## REMARKS

## Amendment to the Drawings

Appln. No. 10/808,828 Reply to Office Action of 3/11/2005 Annotated Page showing changes, Sheet 1

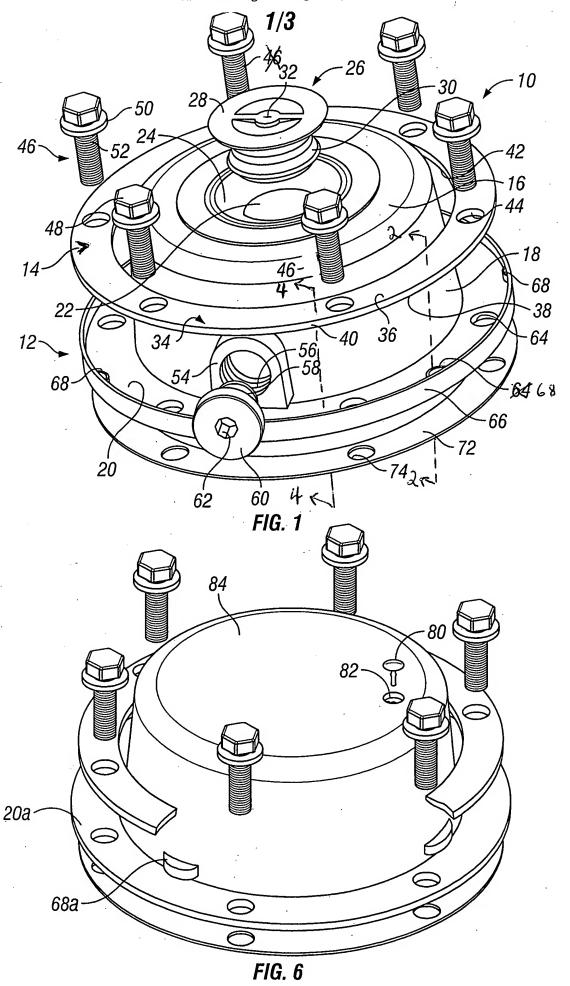
The Applicant has noted the objections to the drawings and has supplied numbers to make it clear that the shank 52 of the fastener 46 extends into the tapped opening 76, with threads 52 registering with and being gripped in the tapped opening 76. In addition, there have been several other changes in the drawings, to eliminate ambiguities and errors. The fasteners, generally designated 46, each have a head portion 48, a flange or washer portion 50 and a threaded shank portion 52. The hold down ring is generally designated 14, but it includes a body portion 36 as well as radially outer and inner edge portions 40, 42 and upwardly and downwardly directed faces 36, 38. Any minor errors that may have occurred are being corrected to ensure that the numbers are correctly placed in the replacement sheets.

The attached two sheets of drawings includes changes to Fig. 1, 3, 4 and 5. These sheets, which includes Fig. 1 and 6 on 1/3 and Figs. 2-5 on 2/3, replace the original sheets. Annotated sheets showing the changes are also attached.
